**RAI 255-8285****DRAFT Question No. 03.08.05-7**

### **Unresolved Question No. 03.08.05-9**

**DRAFT Question No. 03.08.05-18**

**Figure 1. Settlement Distribution Contour for Construction Sequence Analysis**

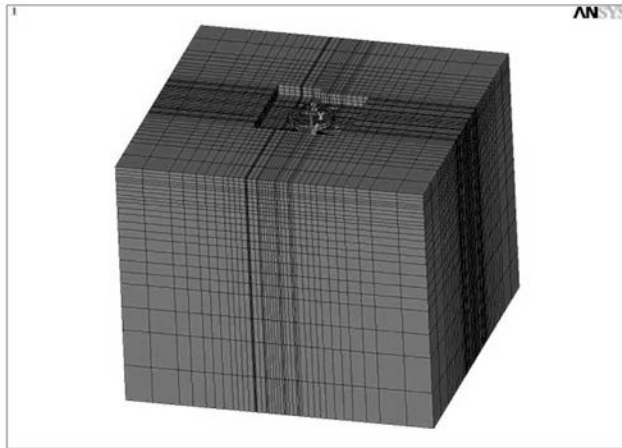
NRC Feedback: Generally, it is expected that the softer soil profile (profile #1) would govern the design; however, sometimes other soil stiffness cases govern the design, and thus, should be considered or further justification provided. Also, explain how soil stiffness values were determined for the static load cases and dynamic seismic load case, which are expected to be different. In addition, see staff comment below regarding how values of soil springs were determined which relates to this staff request.

NRC Feedback: The description of the construction sequence for the basemat and structures on the NI, in what stages (e.g. up to what elevations) should be described in the technical report and summarized in the DCD.

- 1) The construction sequence analysis for the NI common basemat is described in section 5.0 of technical report (APR1400-E-S-NR-14006-P, Rev. 1). From the technical report, the settlements distribution contour for soil profiles S1 and S8 show that soft soil profile (S1) governs the stiff soil profile (S8) due to the concentration of settlement around the NI common basemat.

Based on the characteristic of soil profiles S1 through S8, of which soil layers consist of sand, soft rock or rock, the settlements during construction shall not govern for sand and/or rock site because the total amount of applied loads on the soil profiles S1 through S8 during construction is less than after construction. In addition, reinforcements or supports for building structures during concrete pouring and hardening are not performed in the DC application phase. Therefore, the design of building structures is not affected by the results of the construction sequence analysis if the settlement does not exceed DCD Table 2.0-1 specified criteria. If the settlement exceeds the acceptance criteria in the DCD Table 2.0-1, the construction sequence will be modified to meet the acceptance criteria in DCD Table 2.0-1 by the COL applicant.

**Figure 3. Dimension of Construction Sequence Foundation Media Model**

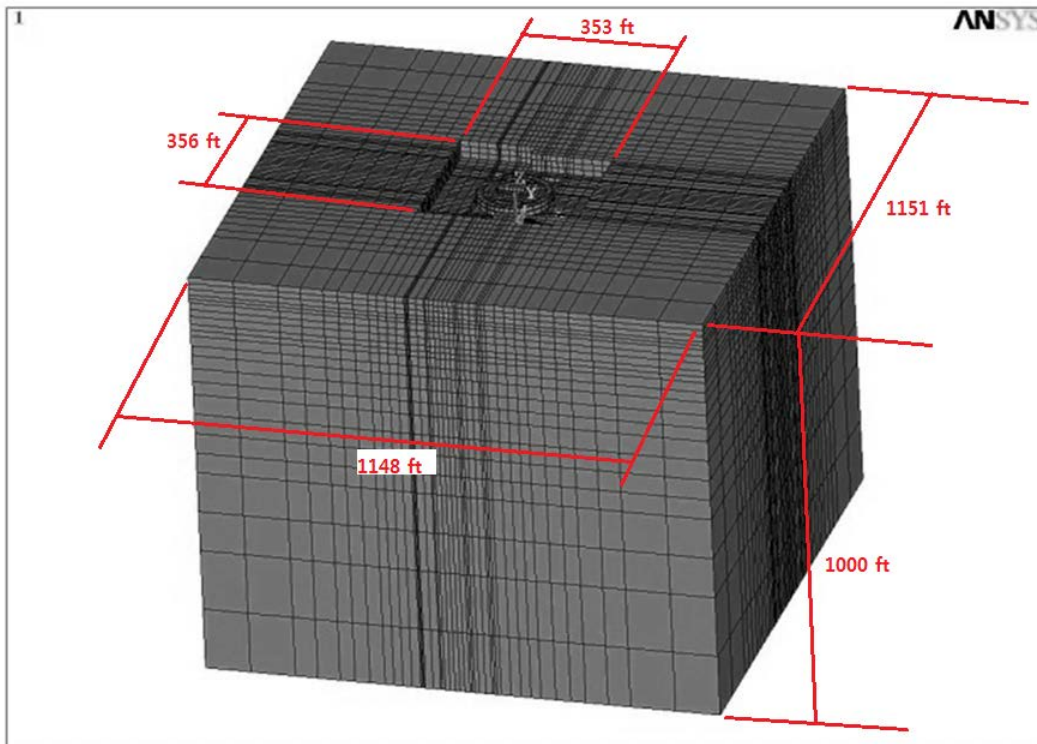
NRC Feedback: In addition to all of the above feedback, some items that were supposed to be addressed in the related RAI 255-8285 Questions 03.08.05-9 and 03.08.05-18, that referred to this RAI for the information, were not provided or adequately described. The additional information relates to criteria in SRP 3.8.5.II.4 E, J and K. One example of missing information in the case of criteria in SRP 3.8.5.II.4 K is: modeling of the soil stiffness (e.g., how values of soil springs were determined, including methodology/equations) for static loads and dynamic

(seismic) loads which would be expected to be different, and would be expected to be a function of soil type (granular vs. cohesive), foundation size, and time (short term vs long term), as well as how the soil springs were distributed across the foundation. In addition to the criteria in SRP 3.8.5.II.4 E, J and K, further guidance is provided in the NRC document entitled, "Technical Rationale for Enhancements to Seismic and Structural Review Guidance" on NRC ADAMS (ML14238A161), under the section Technical Issue No. 7, which also references a section in the U.S. Army Corps of Engineers (USACE) Manual No. 1110-1-1904. In addition, there is also guidance in a paper entitled, "Structural Design Challenges in Design Certification Applications for New Reactors," Proceedings of the ASME 2011 Pressure Vessels & Piping Division Conference, PVP2011-57600. Therefore, the applicant is requested to describe how settlements and construction sequence were evaluated to address the analysis and design parameters discussed in SRP 3.8.5.II.4 E, J and K, which appears to be lacking in this response and in RAI 255-8285 Questions 03.08.05-9 and 03.08.05-18.

- 3) Foundation size: The construction sequence analysis model consists of foundation media (soil layer, SOLID185 elements in the ANSYS program) and the NI common basemat. To capture the Boussinesq effect in soils, the foundation media model is used instead of the soil spring model. For the basemat analysis and construction sequence analysis with actual site profiles, the foundation media model developed with same methodology in technical report (APR1400-E-S-NR-14006-P, Rev. 1) will be used.

The ratio of the width of the basemat is  $(1148 \text{ ft}) / (353 \text{ ft}) = 3.25$  and the ratio of width of the foundation media is  $(1151 \text{ ft}) / (356 \text{ ft}) = 3.23$  which exceeds 3.0. For the depth of foundation, the full depth of the generic soil profile was used; the ratio is  $(1000 \text{ ft}) / (356 \text{ ft}) = 2.81$ .
